PWBA 2020-0804

Addendum No. 1

Armory Commission of Alabama
Pelham Range (UTES #1) Building 2 Restoration
IFB No. AC-22-B-0036-S

7. Refer to Sheet M200

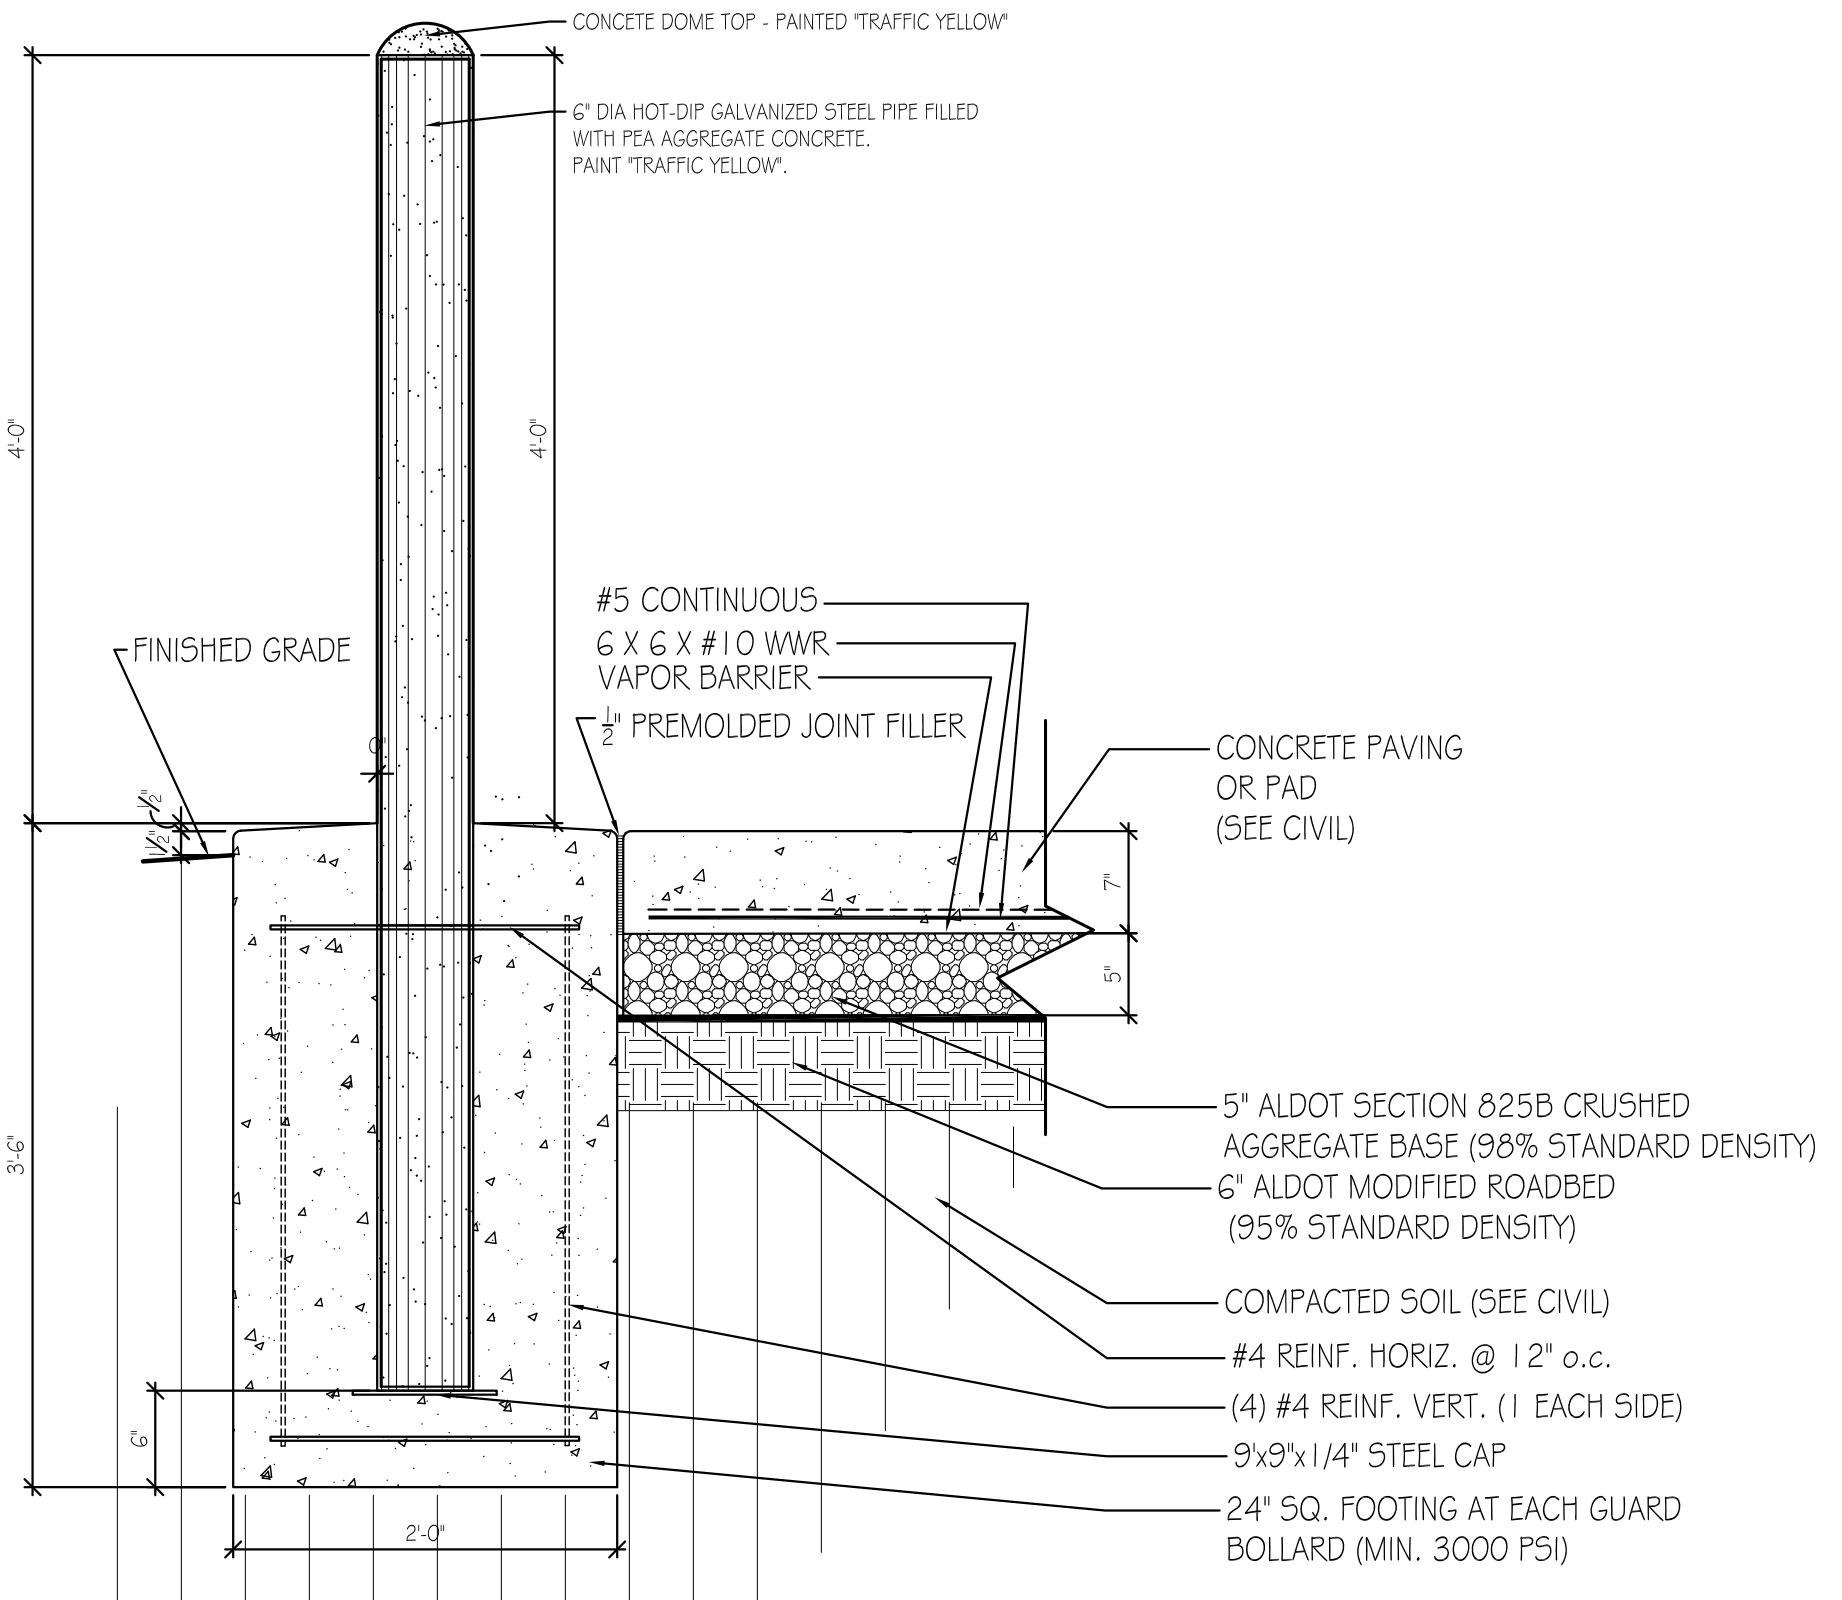
- A. Added a note to show which of the 6 ERF's each of the two starters control.
- B. Corrected the leader location on drawing keynote 10.
- C. Adding the location of the CO monitor on the plans.
- D. Shown sensor symbol on the plans. Keynote 13 indicates a space sensor.
- E. Adds notes to designate which of the 6 ERF's are controlled by each of the 2 starters shown on the plans.
